Addendum No. 2
January 15, 2020

Project: Sanford School of Medicine First Floor Renovations
Sioux Falls, South Dakota
OSE Project #R0620--07X
Architecture Incorporated Project #2863

**SANFORD SCHOOL OF MEDICINE
FIRST FLOOR RENOVATIONS**
FLOOR PLANS - VENTILATION & A/C

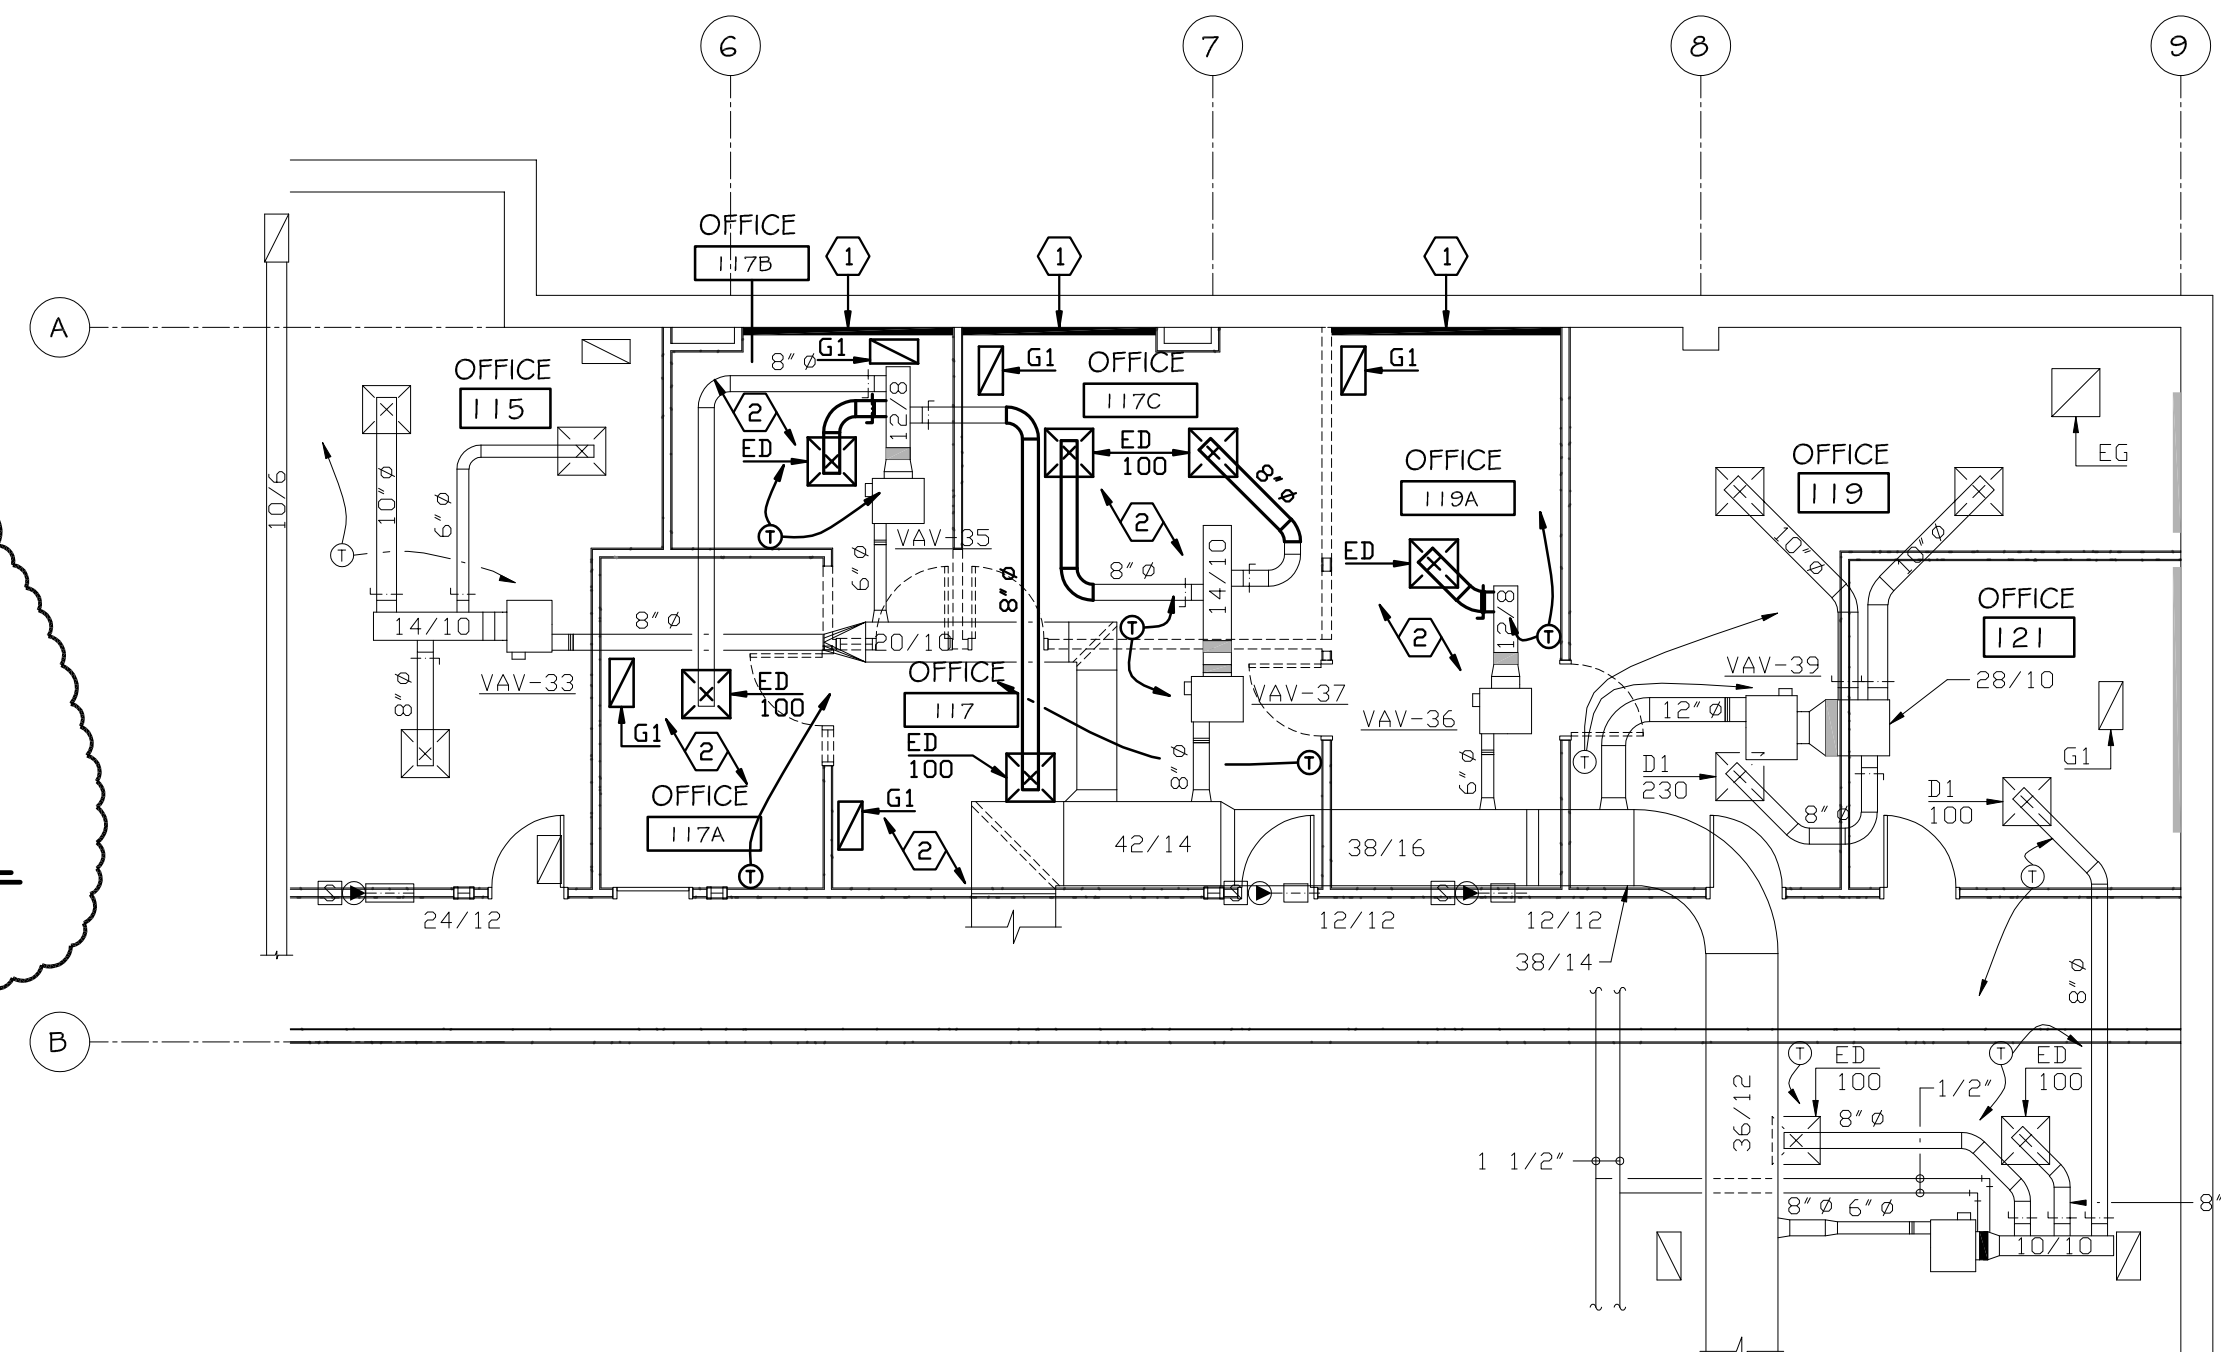
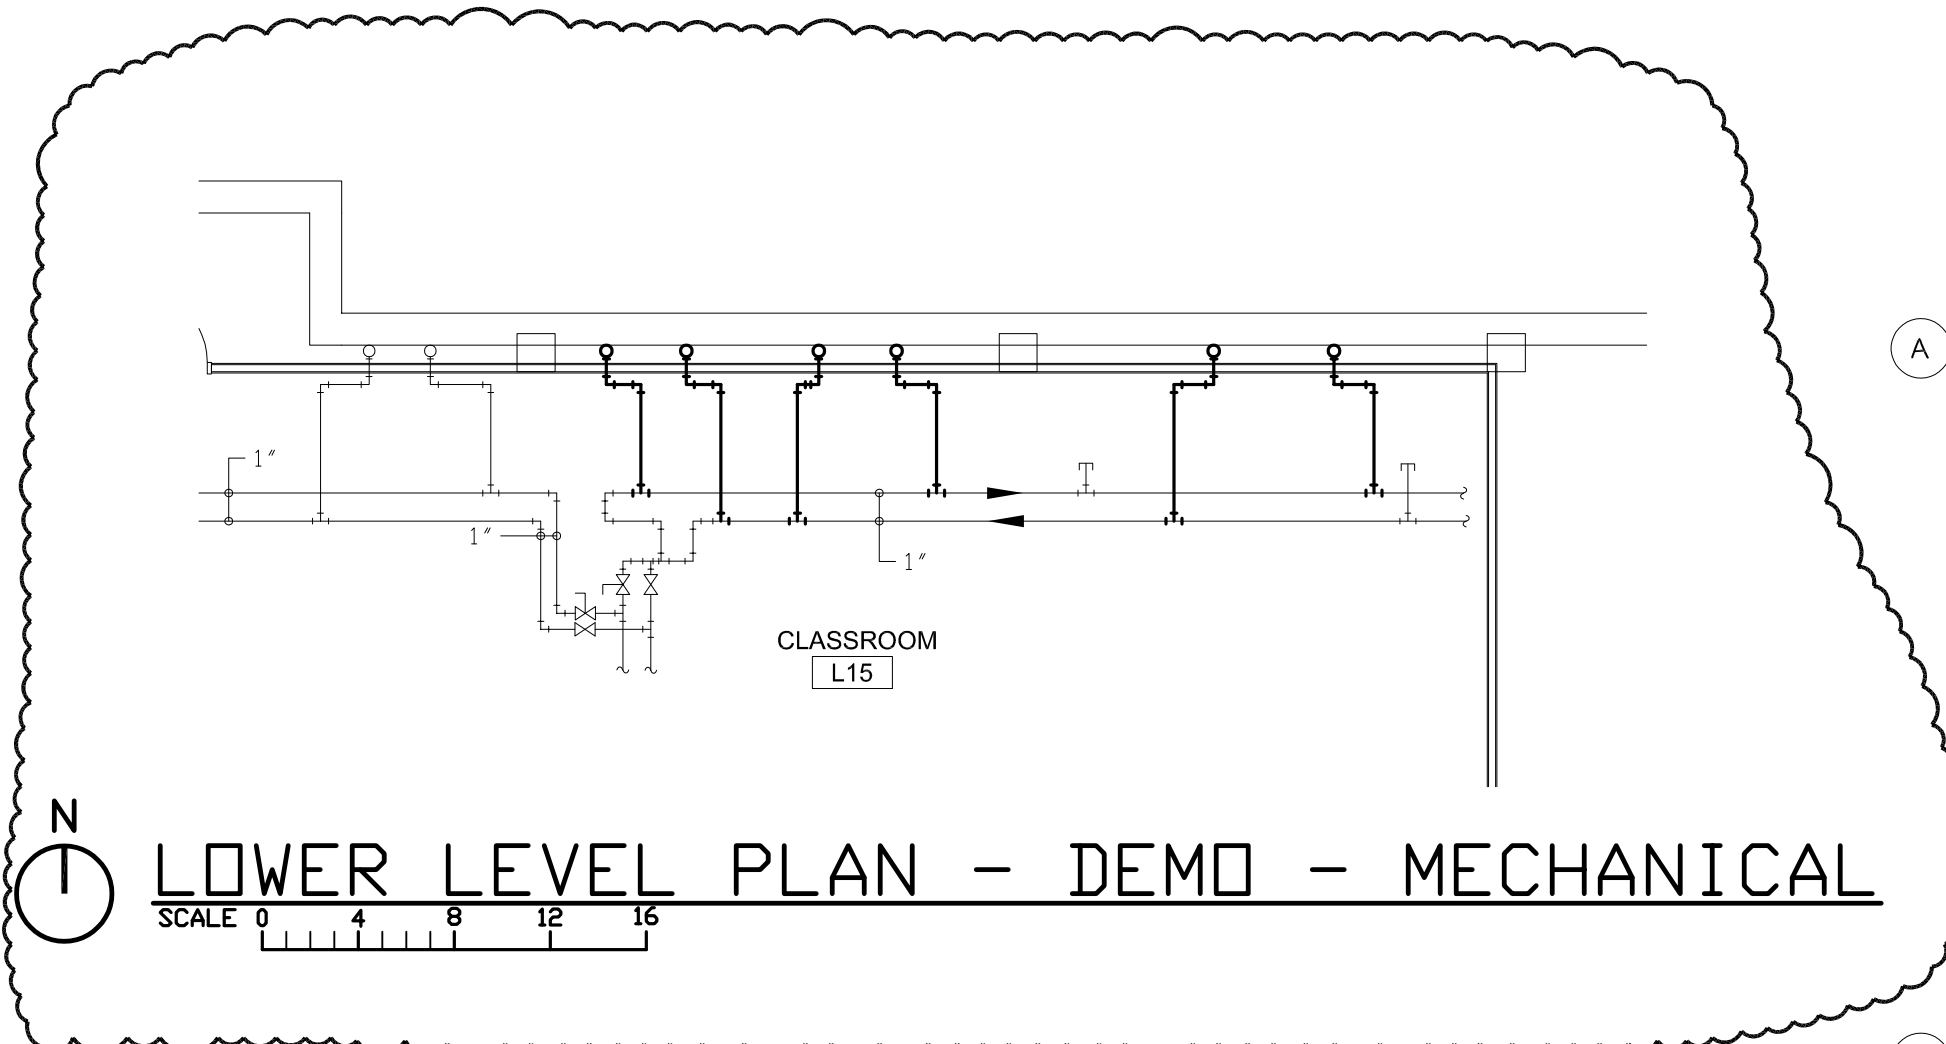
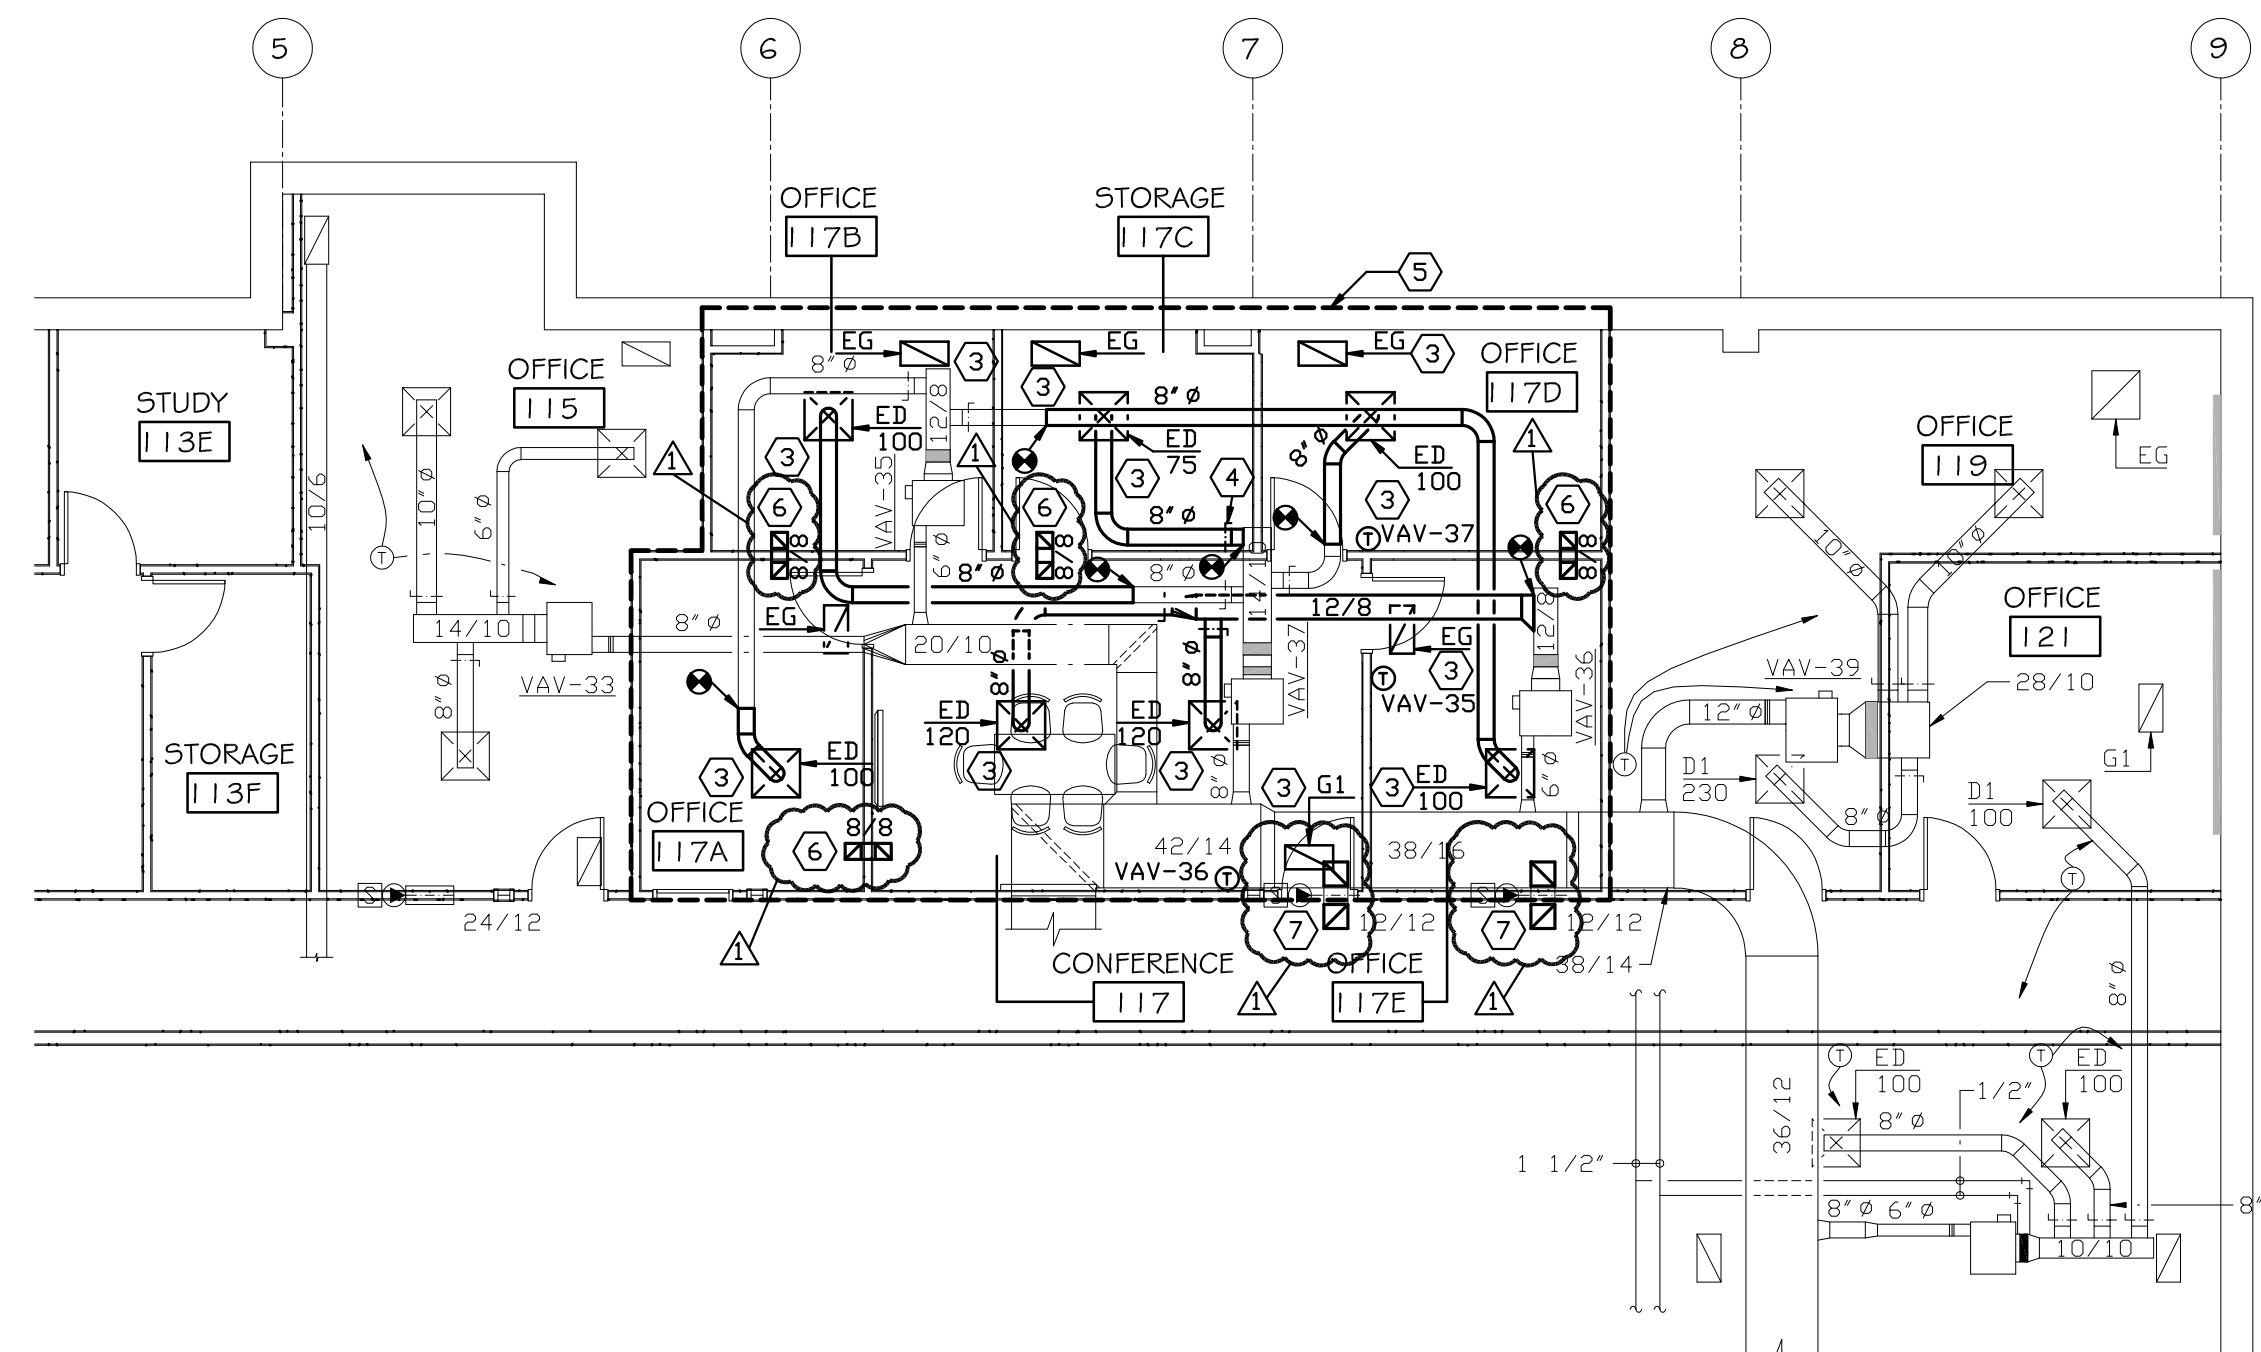
- 1) DRAWING SHEET 8.10 – FLOOR PLANS – VENTILATION & A/C
 - a) Add 8/8 transfer air ducts to the following rooms: "OFFICE 117A", "OFFICE 117B", "STORAGE 117C", "OFFICE 117D". See revised drawing sheet 8.10, dated 1-15-20.
 - b) Provide sound attenuation elbows turned up on existing 12/12 transfer openings on both sides of wall from "CONFERENCE 117" and "OFFICE 117E". See revised drawing sheet 8.10, dated 1-15-20.
 - c) Added Lower Level Plan – Demo – Mechanical. See revised drawing sheet 8.10, dated 1-15-20.
